MEETING SUMMARY DISTRIBUTION

Docket No. 50-237

SUBJECT: SUMMARY OF MEETING WITH COMMONWEALTH EDISON COMPANY - SENIOR SEISMIC REVIEW TEAM TOUR OF DRESDEN UNIT NO. 2

Acceleration Diagram
Under Seismic Loads
 N-S direction

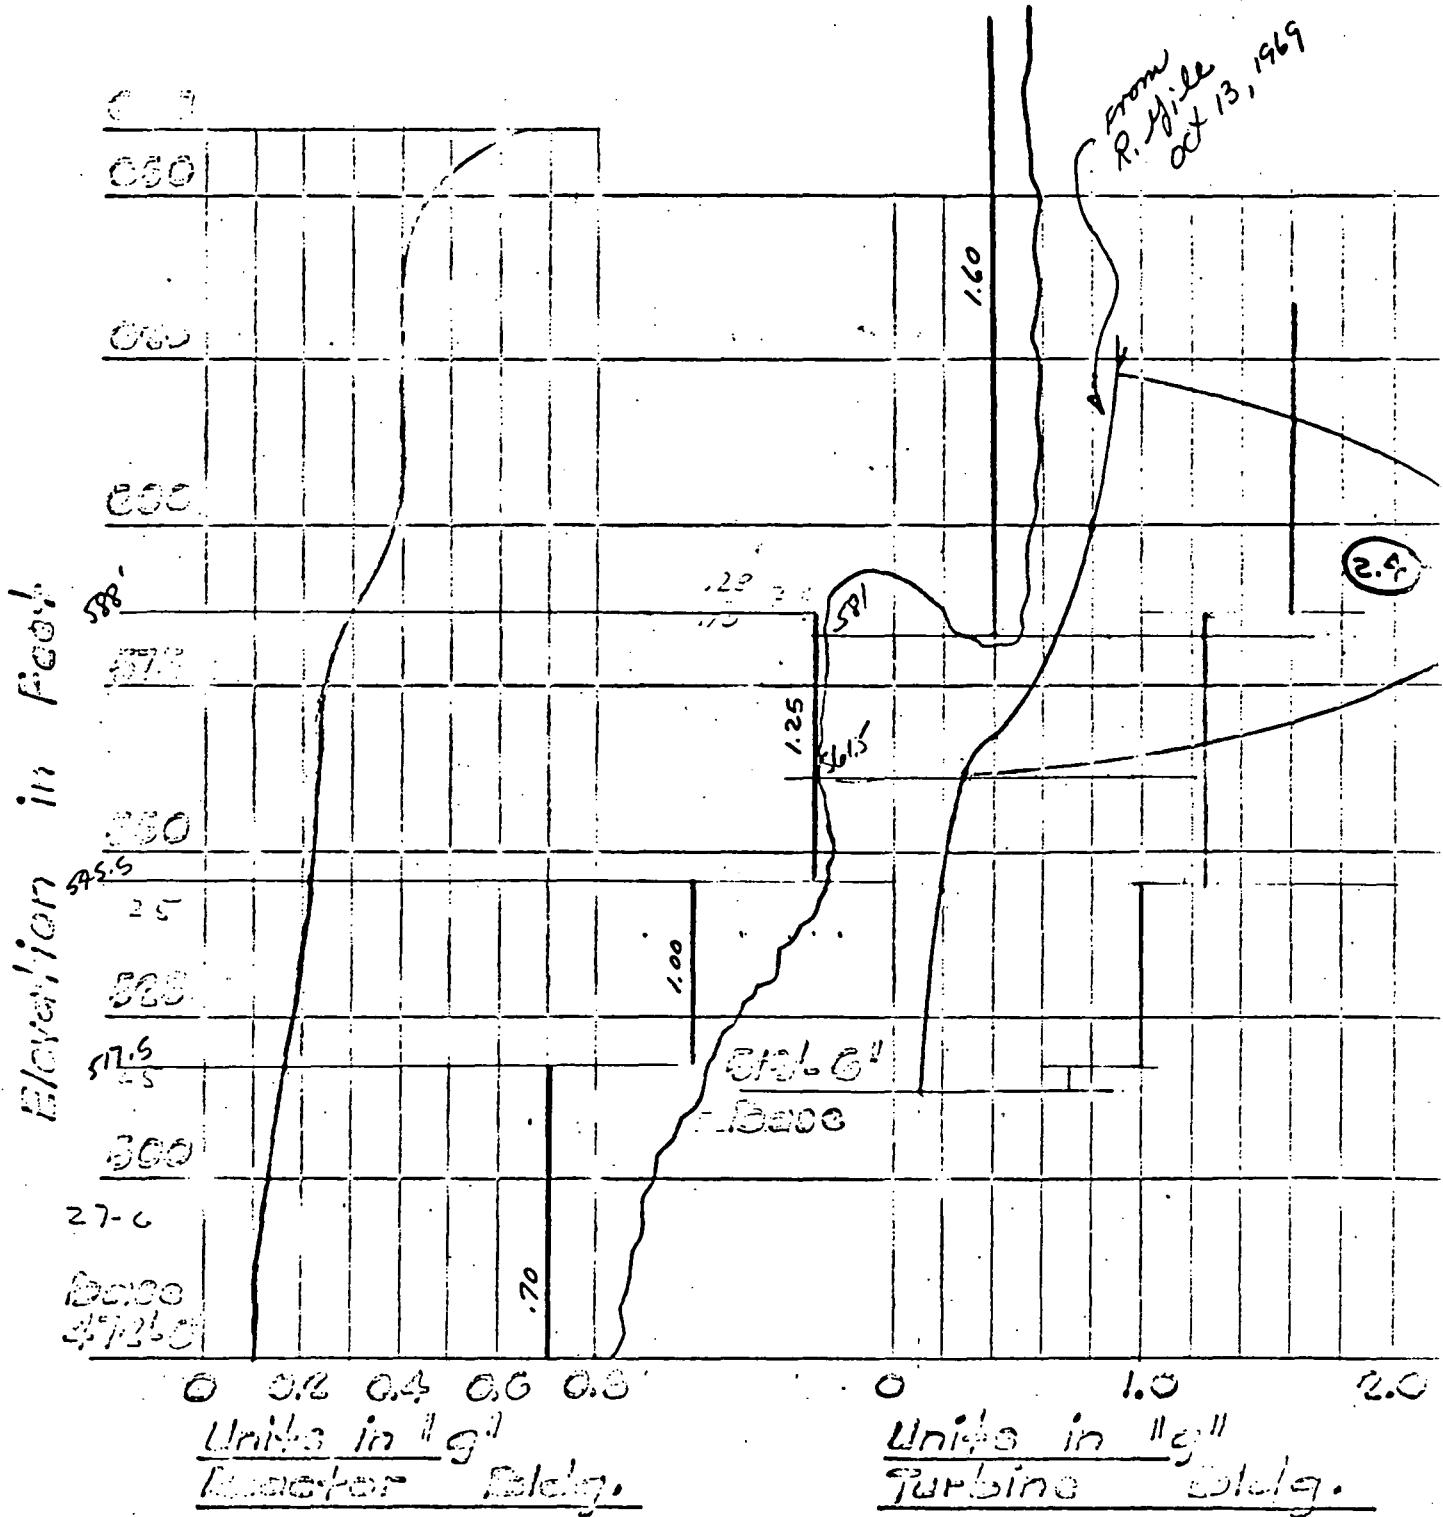
Ralph says the Turbine Bldg N-S
Acceleration curve is incorrect.

The 2.4g at 581 is more like
.8g at 600' and .9g at 625'

Therefore the attached shows the
Reactor Bldg coefficients can be
used in the Turbine Bldg.
